Flat A, 13 Crossfield Road,  
London, NW6 4NS

Basement Impact Assessment  
Audit

For  
London Borough of Camden

Project Number: 12466-54  
Revision: D2

**Figure 10: DCA for the front walls of No. 12 and 11**

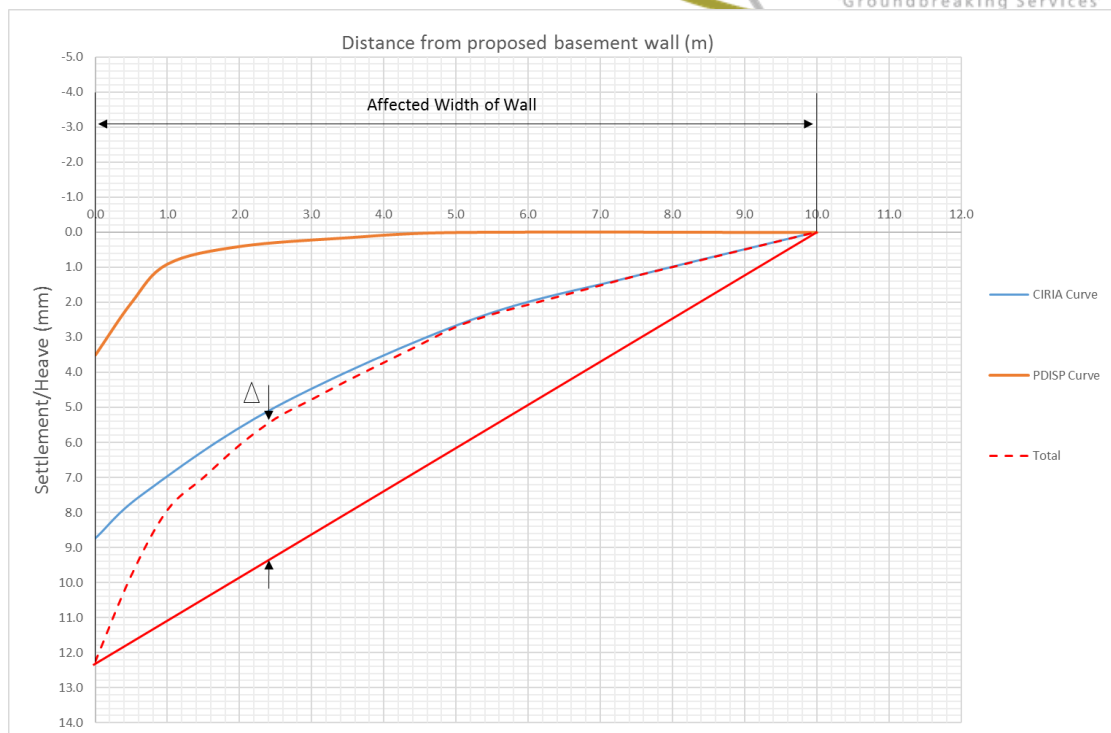
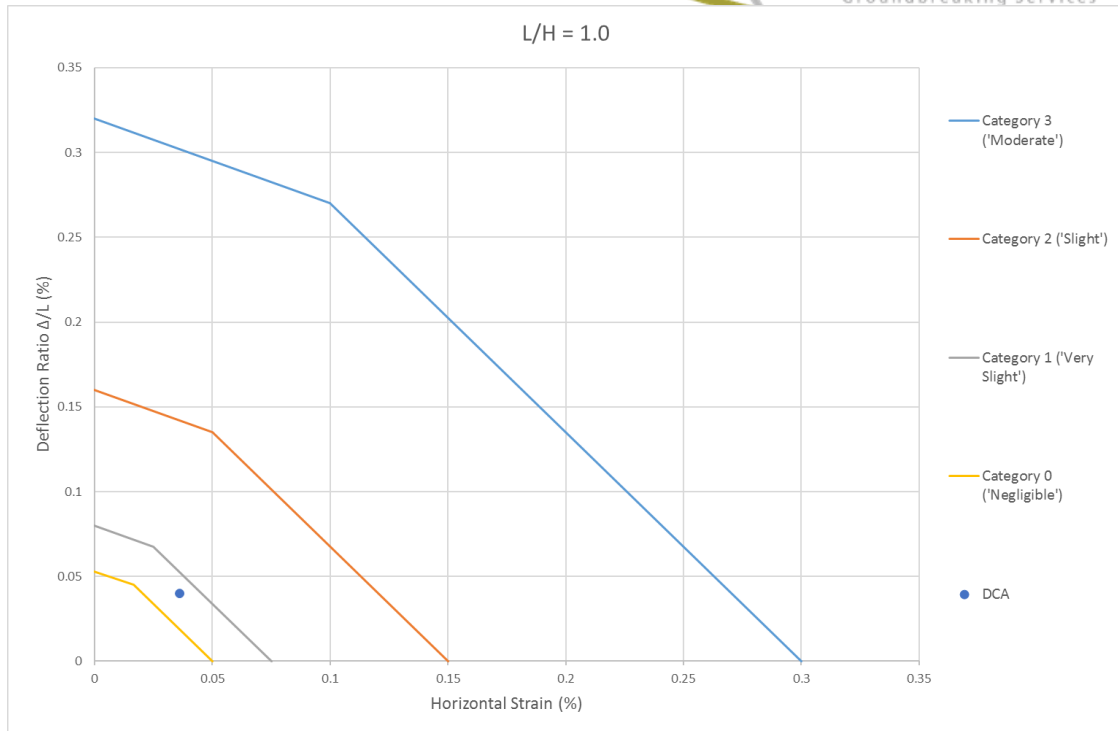
- 1.7. A quantitative Ground Movement Assessment and Damage Impact Assessment were conducted by Chelmer Consultancy Services. A Damage Category Assessment indicates damage to fall between Burland Category 1 (Very Slight) and Category 0 (Negligible) for Nos. 11 and 12 Crossfield Road. The GMA should be revised to also consider 37 Adamson Road.

- 4.9. Although it is stated that the GMA considers the worst case sections, and therefore has not been undertaken for other neighbouring properties, it is noted that the geometry and proximity of 37 Adamson Road may make it susceptible to ground movements and corresponding damage impacts. Whilst the PDISP analysis may indicate minimal settlements, retaining wall installation and excavation effects have not been presented. Consequently, the GMA and damage impact assessment should be updated to include 37 Adamson Road.
